MSB Service Bulletin
No. MSB-E4-007/4

MANDATORY SERVICE BULLETIN

No. MSB-E4-007/4
SUPERSEDES DOC. No. MSB-E4-007/3

Replacement of Waste Gate Controller

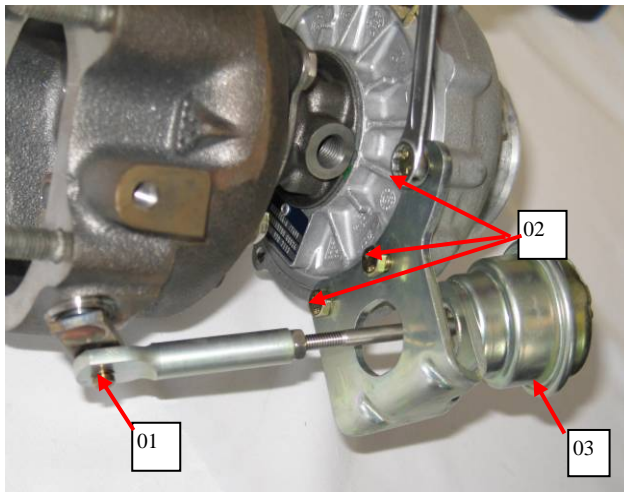
Removal of installed Waste Gate Controller:

1. Disconnect Hose at the top of the Waste Gate Controller
2. Remove three M6 Bolts [02]
3. Remove Circlip [01]
4. Disconnect rod from waste gate lever and remove waste gate controller [03]

Install new Waste Gate Controller according to table section 3.1.

1. Install the three M6 Bolts [02] and torque them with 7 Nm
2. Attach external pump to the top of the Waste Gate Controller and apply pressure till the rod starts to move
3. Connect rod to waste gate lever
4. Adjust Waste Gate Controller according to Engine Maintenance Manual E4.08.04, Chapter 81-00-32.

Note: For fixing of the rod on the waste gate lever use new circlip.
